FIELD CHANGE ORDER

TU77A

M

0007

FIGURE 1

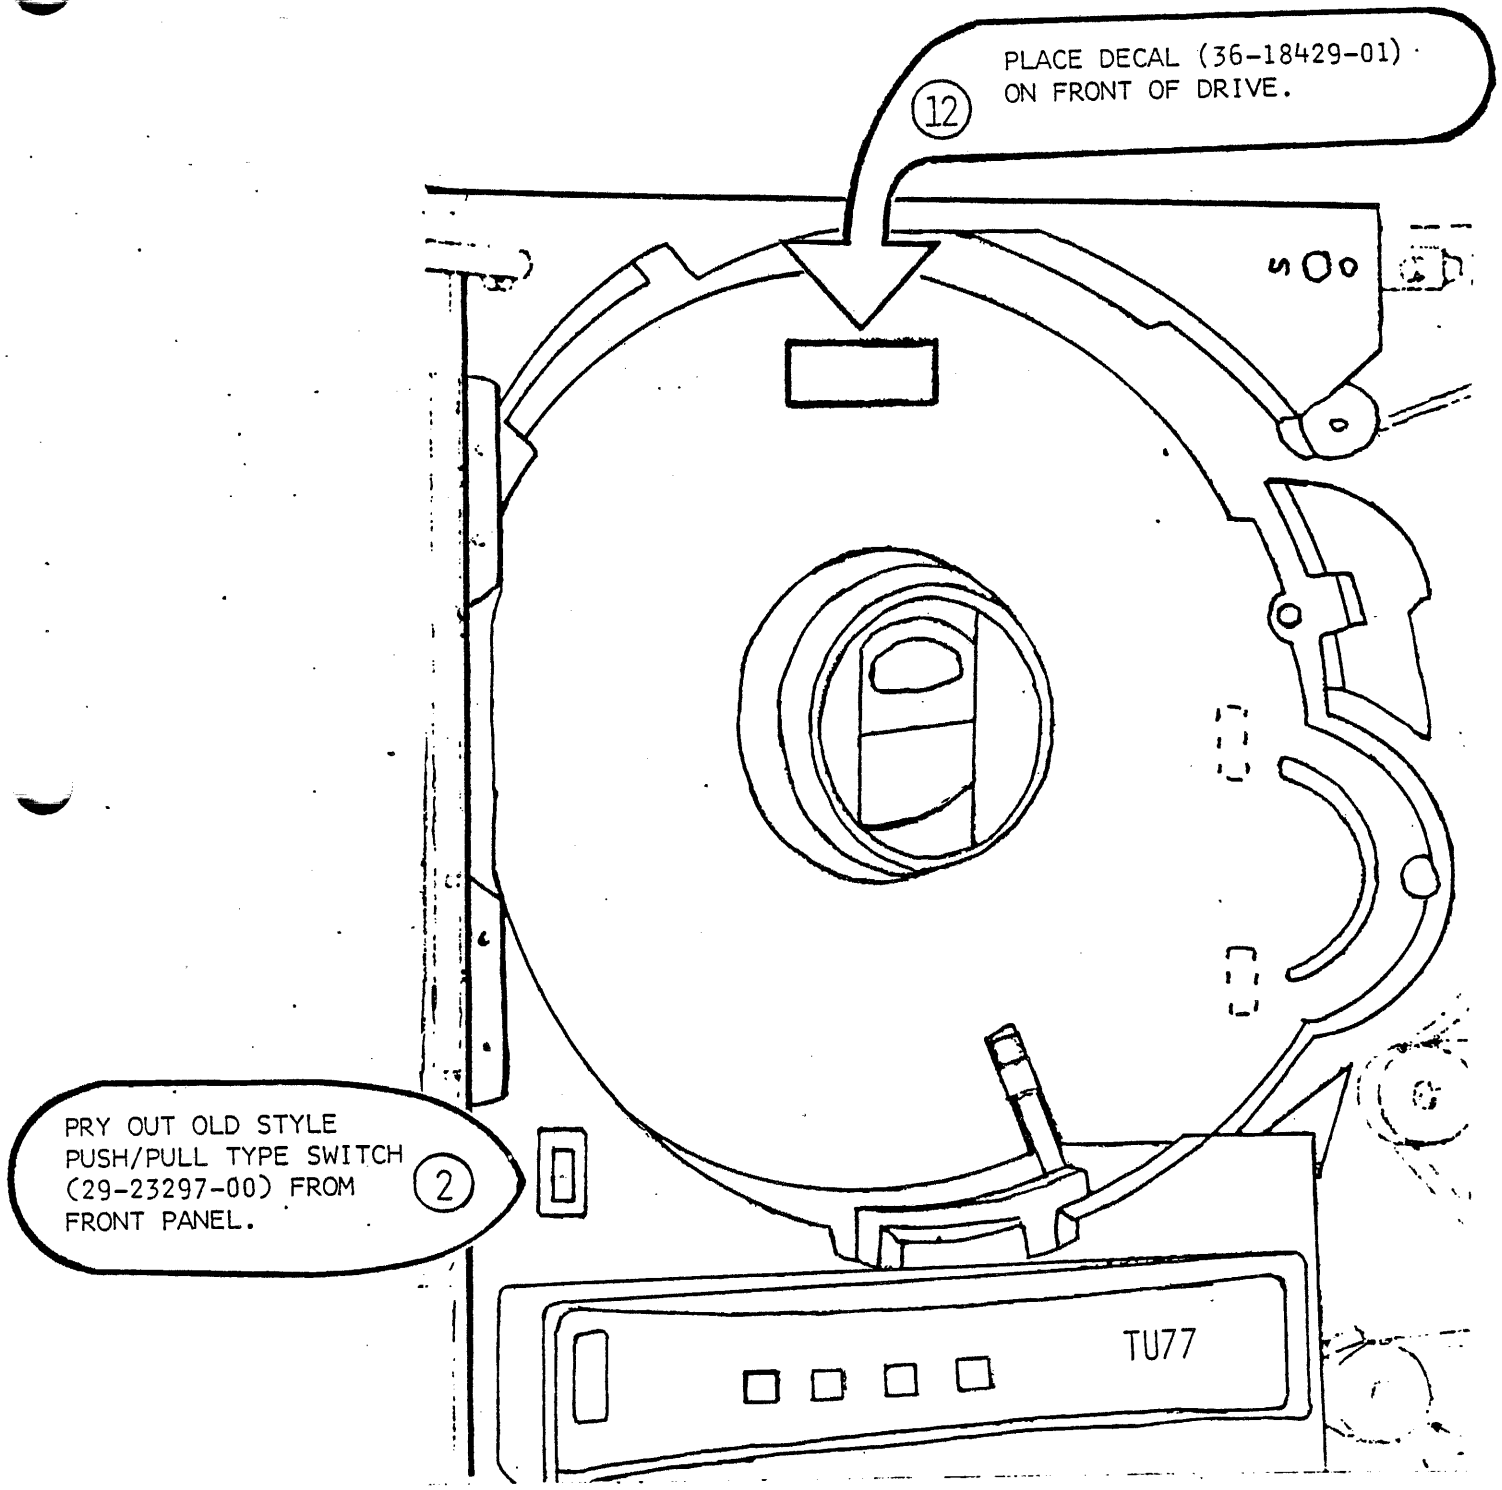
- 1- POWER DOWN DRIVE.
- 2- OPEN MAIN DECKPLATE AND LOCK IN PLACE.
- 3- REMOVE AND DISCARD SWITCHES S2 AND S3. INSTALL SWITCHES, VENDOR PART NUMBER 506-0023, IN S2 AND S3 LOCATIONS. (FIGURE 1)
- 4- MOUNT PRE-ASSEMBLED SWITCH ASSEMBLY ON INBOARD SIDE OF PRESENT SWITCH MOUNTING BRACKET IN HOLES JUST ABOVE AND BELOW S2 AND S3. (FIGURE 1)
- 5- REMOVE HOSE FROM S2 (DOOR EDGE SIDE). INSTALL HOSE ON CENTER OF PLASTIC T COMING FROM NEW SWITCH ASSEMBLY S16.
- 6- CONNECT OTHER BRANCH FROM T ON S16 TO S2.
- 7- REMOVE HOSE FROM S3 (DOOR EDGE SIDE). INSTALL HOSE ON CENTER OF PLASTIC Y COMING FROM NEW SWITCH ASSEMBLY S17.
- 8- CONNECT OTHER BRANCH OF Y FROM S13 TO S3. USE CABLE TIE, IF NECESSARY, TO DRESS TUBE GOING TO LOOP PORT. RUN TIE THROUGH HOLE. (FIGURE 1)

- 9- REMOVE HOSE FROM S2 (INBOARD SIDE). INSTALL IT ON CENTER OF Y COMING FROM S16 (INBOARD SIDE).
- 10- CONNECT OTHER BRANCH OF "Y" FROM S16 TO S2 (INBOARD SIDE).
- 11- REMOVE HOSE FROM S3 (INBOARD SIDE). INSTALL IT ON CENTER OF T COMING FROM S17 (INBOARD SIDE).
- 12- CONNECT OTHER BRANCH OF "T" FROM S17 TO S3 (INBOARD SIDE).
- 13- ENSURE HOSES ARE FREE OF ANY OBSTRUCTIONS AND THEY HAVE PROPER CLEARANCE BETWEEN FRAME AND DECKPLATE WHEN DECKPLATE IS OPENED AND CLOSED.
- 14- MAKE THE FOLLOWING ELECTRICAL CONNECTIONS:
 - A) BLACK/WHITE WIRE FROM S2 TO S16 PIN 2.
 - B) ORANGE/WHITE JUMPER FROM S16 PIN 1 TO S2 PIN 1.
 - C) BLACK/WHITE WIRE FROM S3 TO S17 PIN 2.
 - D) PURPLE/YELLOW JUMPER FROM S17 PIN 1 TO S3 PIN 2.
- 15- LOAD AND UNLOAD TO ENSURE PROPER OPERATION.

NOTE: S16 & S17 ARE MOUNTED BEHIND PLATE.

FIG.1 (Old style)

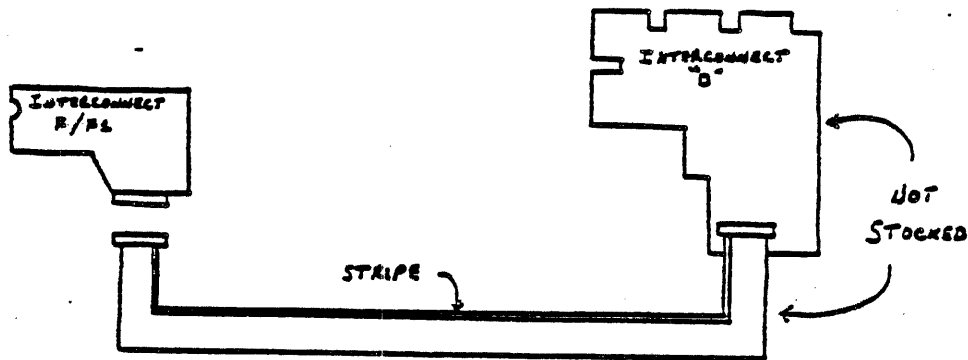
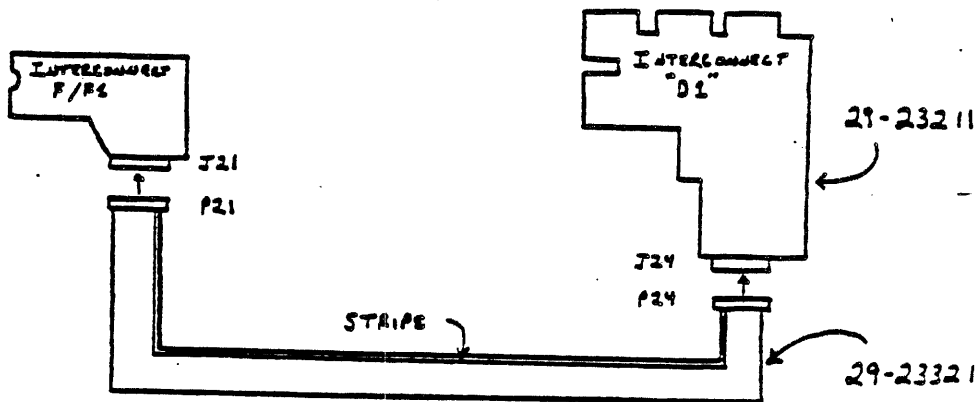
Early TU77 transports shipped with the Interconnect "D" backplane. This backplane includes a cable which is soldered to the etch and runs up to the interconnect F/F1 PCBA on the base assembly (see Fig. 1). Later models (approximate serial #5250 and up) use the Interconnect "D1" backplane which has a detachable cable (See Fig. 2). Logistics will not stock the Interconnect "D" assembly but rather will stock the Interconnect "D1" (29-23211) and the cable (29-23321) separately.

Consequently, if an Interconnect "D" backplane/cable assembly should fail in the field, it must be replaced with the newer style "D1" and the cable assembly must be ordered as a separate line item.

FIG. I

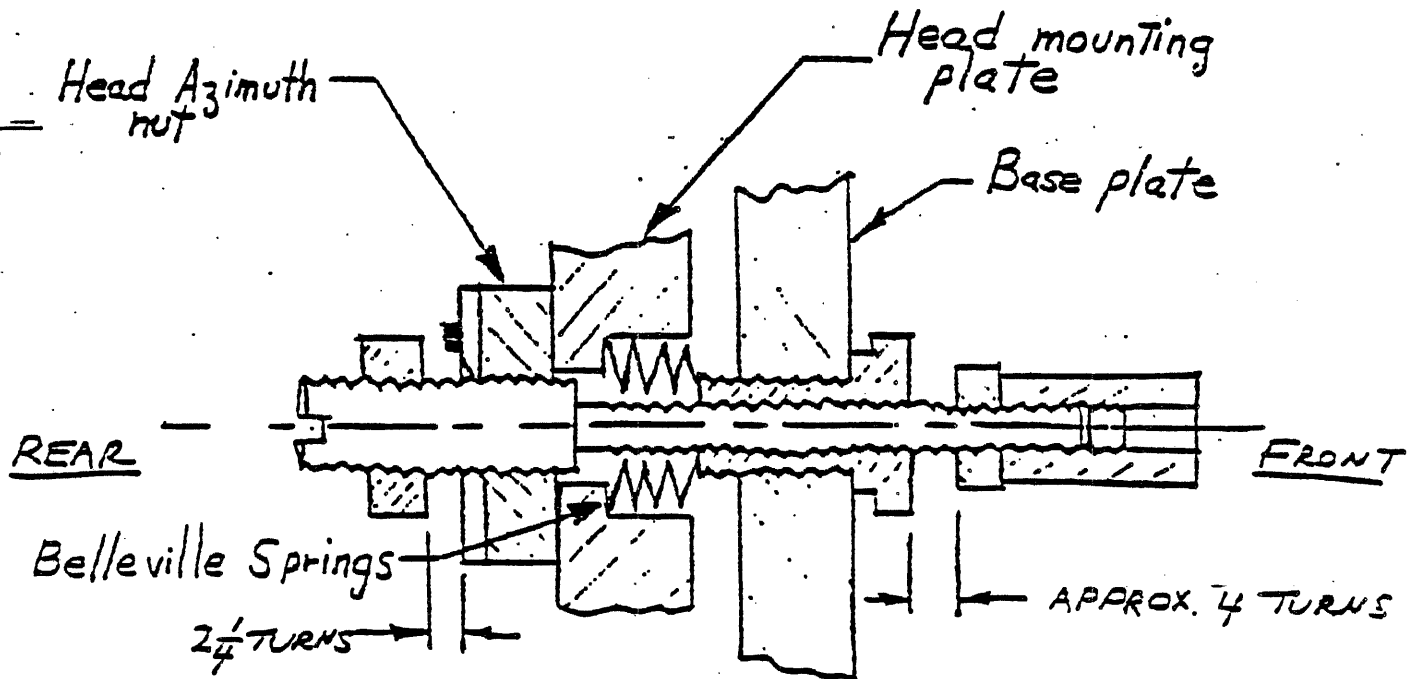
THE HEAD AZIMUTH ADJUSTMENT PROCEDURE GIVEN IN THE TU77 M.M. EK-2TU77-TM-001 SECTION 6.5.8.3, IS BASICALLY CORRECT. HOWEVER, THERE HAVE BEEN SOME CHANGES IN THE MOUNTING HARDWARE SINCE IT WAS WRITTEN AND CLARIFICATION IS IN ORDER.

REFER TO FIGURE 1. THE ADJUSTING SCREW NOW PROTRUDES THROUGH THE REAR OF THE HEAD MOUNTING PLATE AND THE HEAD AZIMUTH NUT. THE SCREW IS SECURED IN THE AZIMUTH NUT WITH LOCTITE.

BEFORE THE ADJUSTING SCREW CAN BE TURNED FROM THE FRONT OF THE DRIVE, AS PER THE ADJUSTMENT PROCEDURE, THE LOCTITE SHOULD BE BROKEN BY INSERTING A STRAIGHT BLADE SCREWDRIVER INTO THE REAR OF THE ADJUSTING SCREW AND TWISTING. THE AZIMUTH MAY NOW BE ADJUSTED FROM EITHER THE FRONT OR REAR OF THE DRIVE AND WILL HOLD THE ADJUSTMENT WITHOUT ADDING ANY MORE LOCTITE.

THE ADJUSTMENT IS HELD BY THE PRESSURE OF THE BELLEVILLE SPRINGS IN THE HEAD MOUNTING PLATE.

Figure 1 Interconnect F1 PCBA Adjustments and Test Points

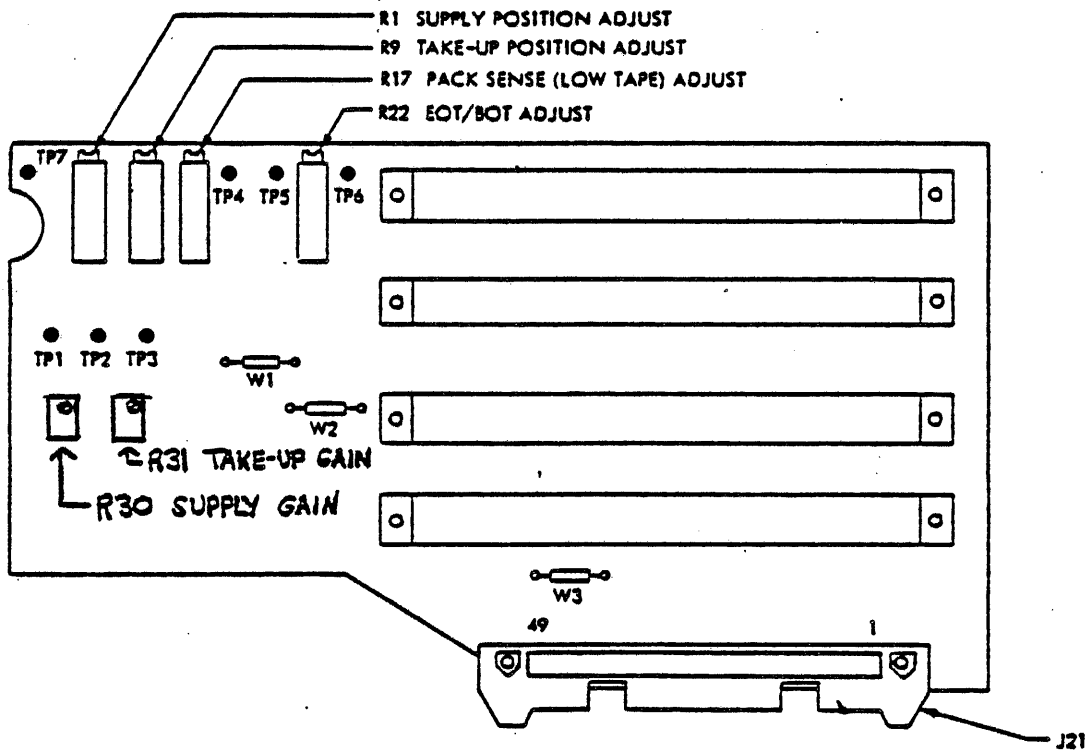
IN ORDER TO REDUCE REEL SERVO CIRCUIT POWER CONSUMPTION AND HEAT DISSIPATION, TWO SERVO GAIN POTS HAVE BEEN ADDED TO THE INTERCONNECT F1 PCBA. THE ACCOMPANYING DIAGRAMS SHOW THE LOCATION OF THE POTS ON THE F1 PCBA AND IN THE CIRCUIT SCHEMATICS. FOLLOWING IS:

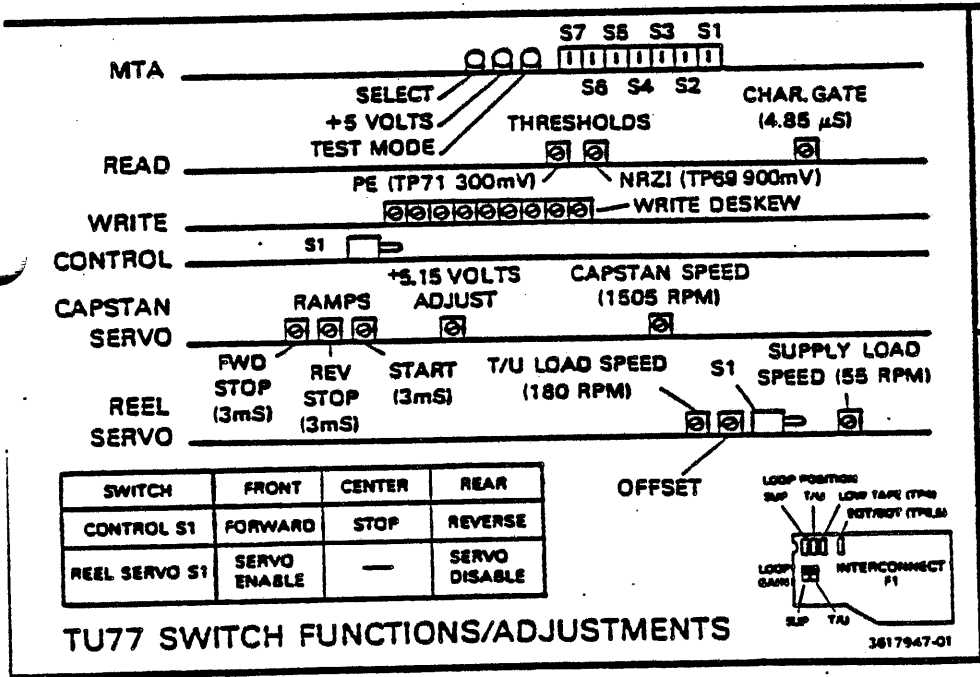
THIS DECAL IS BEING PHASED INTO PRODUCTION DRIVES. ORDER THROUGH SR17. PART NUMBER IS 36-17947-01. IT SHOULD BE PLACED JUST ABOVE THE RIBBON CABLE CLAMPS ON THE LEFT WALL OF THE CARD CAGE.

Figure 2-11 Cabinet with Side Panels and Top Cover Removed

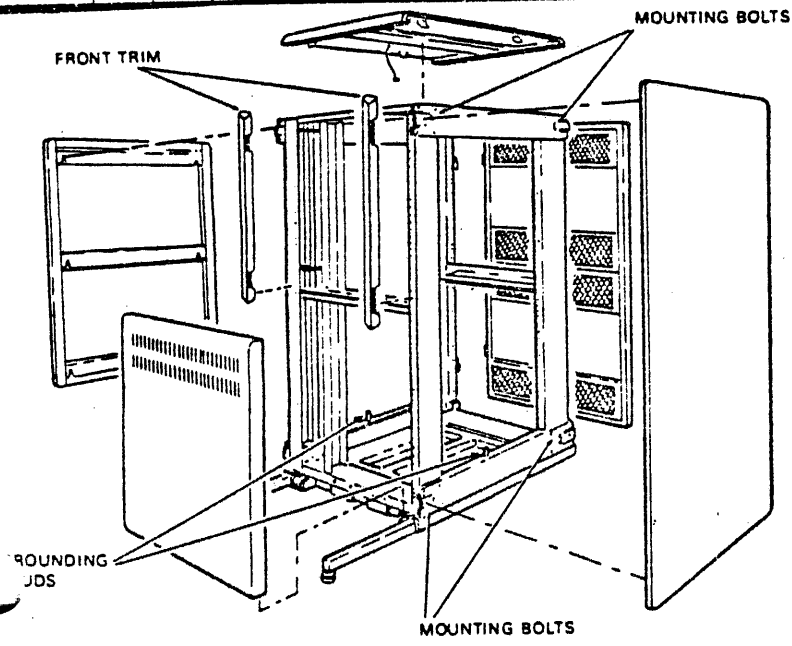
- PAGE 2-12, FIGURE 2-11 CORPORATE CABINET WITH SIDE PANELS AND TOP COVER REMOVED.

DELETE OLD FIGURE 2-11 AND INSERT NEW FIGURE 2-11.

9A. USING THE GREEN/YELLOW GROUND CABLE PROVIDED, GROUND THE TU77 CABINET FRAME TO THE CPU CABINET FRAME. THE GROUNDING STUDS FOR THE TU77 ARE LOCATED ON THE LOWER SIDE FRAME MEMBERS (FIGURE 2-11).

13A. USING THE SHORT GROUND STRAP INCLUDED WITH THE SLAVE TRANSPORTS, GROUND THE MASTER AND SLAVE CABINETS TOGETHER. USE GROUNDING STUDS ON THE LOWER SIDE FRAME MEMBERS (FIGURE 2-11).

Figure 6-7 Forward Start Ramp

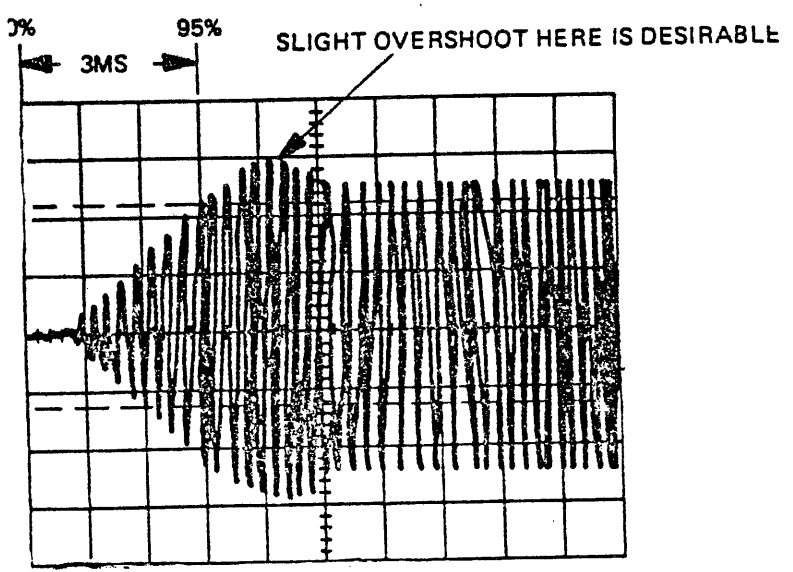
- PAGE 6-16, FIGURE 6-7 FORWARD START RAMP
DELETE OLD FIGURE 6-7 AND INSERT NEW FIGURE 6-7.
- PAGE 6-32, 6.5.8.1 NRZI THRESHOLD ADJUSTMENT
IN STEP 6, CHANGE THE VOLTAGE RANGES TO:
+1020 MV MAXIMUM
+780 MV MAXIMUM
IN STEP 7, CHANGE THE VOLTAGE READING TO 900 MV.
- PAGE 6-66, TABLE 6-15 DATA L READ THRESHOLDS
CHANGE THE NRZI READ LOW THRESHOLD VOLTAGES TO:
TP69 +900 MV +120 MV
TP70 -900 MV ±120 MV
